City of Portland, Maine – Building or Use Permit Application 389 Congress Street, 04101, Tel: (207) 874-8703, FAX: 874-8716

REASON FOR PERMIT: replace outside Stairs/Landing

DATE: 21 / June / 96 ADDRESS: 970 Brighton Ave -
 REASON FOR PERMIT: TO replace outside stairs/hall
 BUILDING OWNER: Ann Kusba
 CONTRACTOR: L & G Builders Co APPROVED: X 1 * 11 * 13
 PERMIT APPLICANT: _____ DENIED: _____

EXAMPLE ONLY
NOT TO SCALE

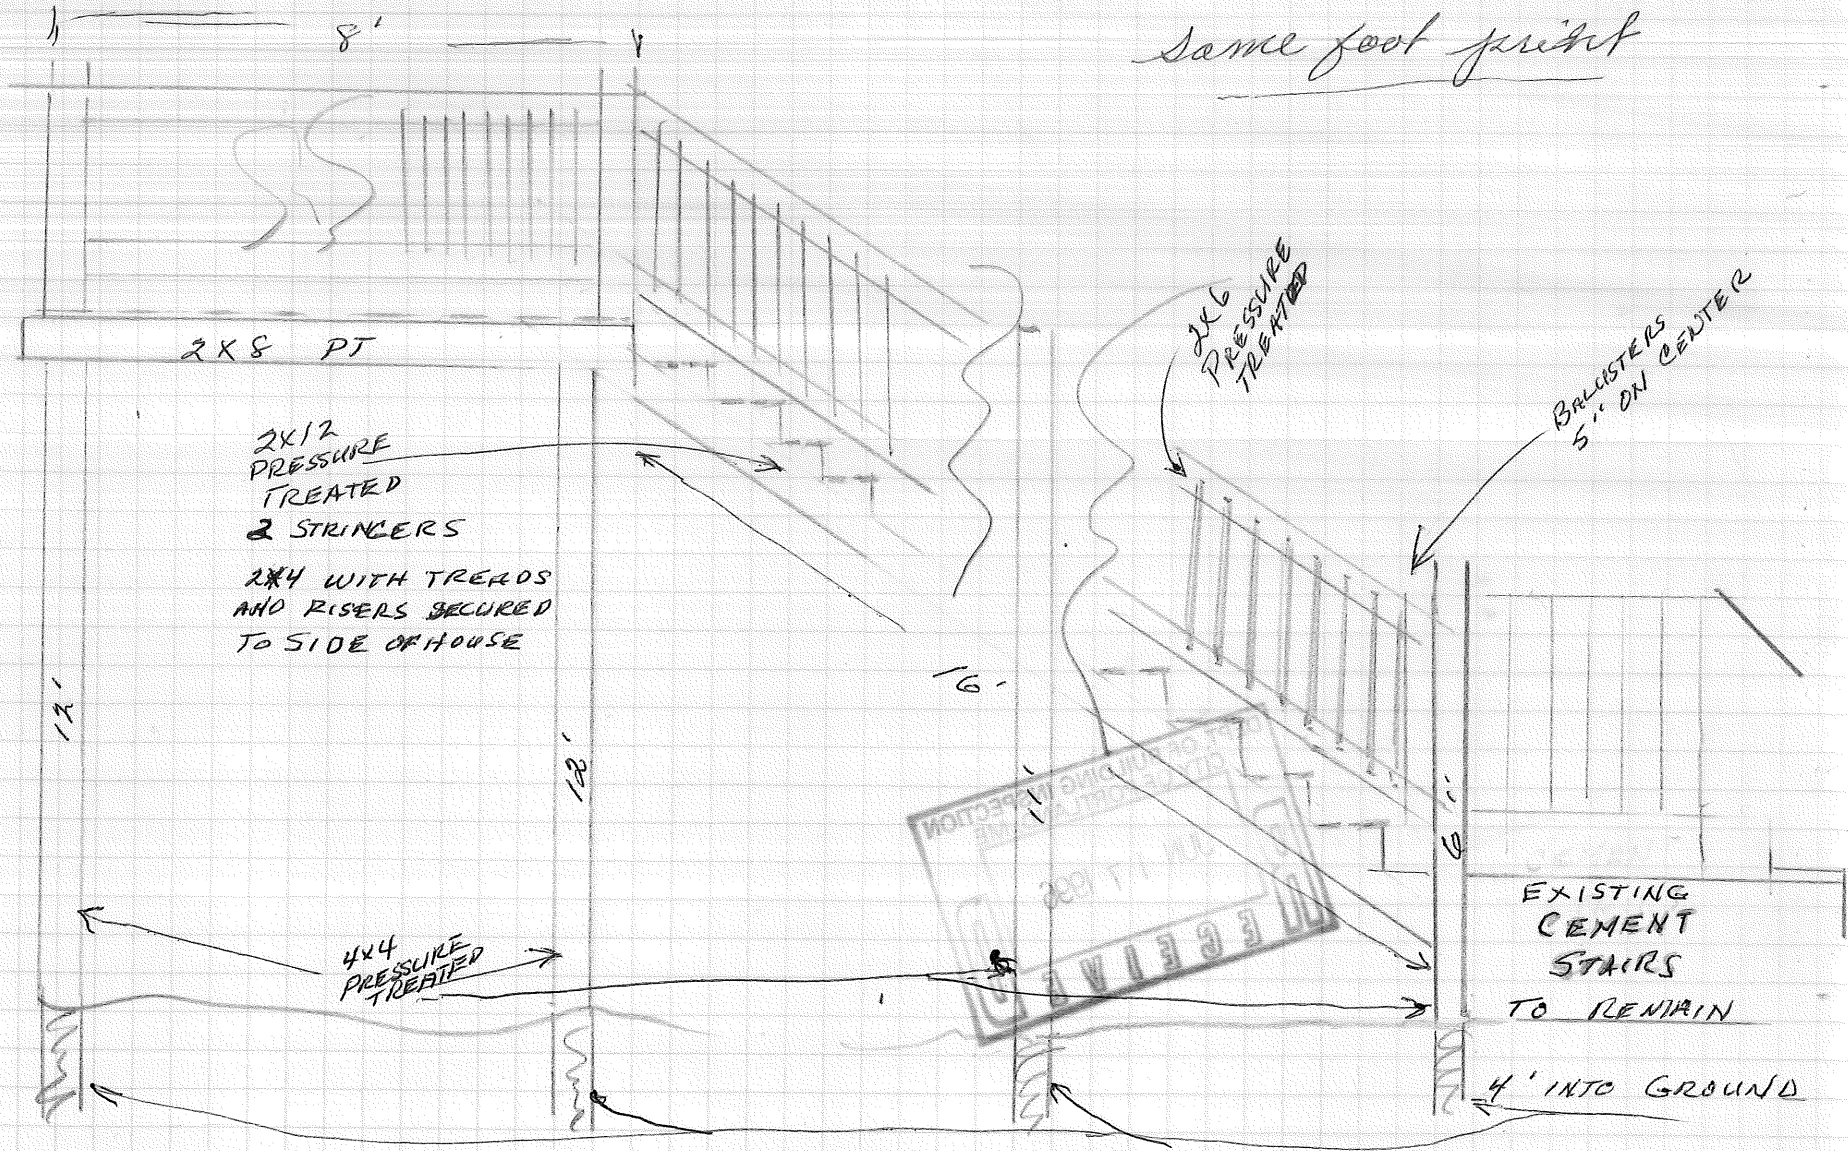
920-960 steps replaced. Cannot verify sonar tubes depth.
Lag bolts used to secure to structure.
Handrail + Ballusters ok.

X 11. Guardrail & Handrails-A guardrail system is a system of building components located near the open sides of elevated walking surfaces for the purpose of minimizing the possibility of an accidental fall from the walking surface to the lower level. Minimum height all Use Groups 42", except Use Group R which is 36". In occupancies in Use Group A, B, H-4, I-1, I-2 M and R and public garages and open parking structures, open guards shall have balusters or be of solid material such that a sphere with a diameter of 4" cannot pass through any opening. Guards shall not have an ornamental pattern that would provide a ladder effect.

X 13. Stair construction in Use Group R-3 & R-4 is a minimum of 9" tread and 8-1/4" maximum rise. ~~All other Use Group minimum 11" tread, 7" maximum rise.~~
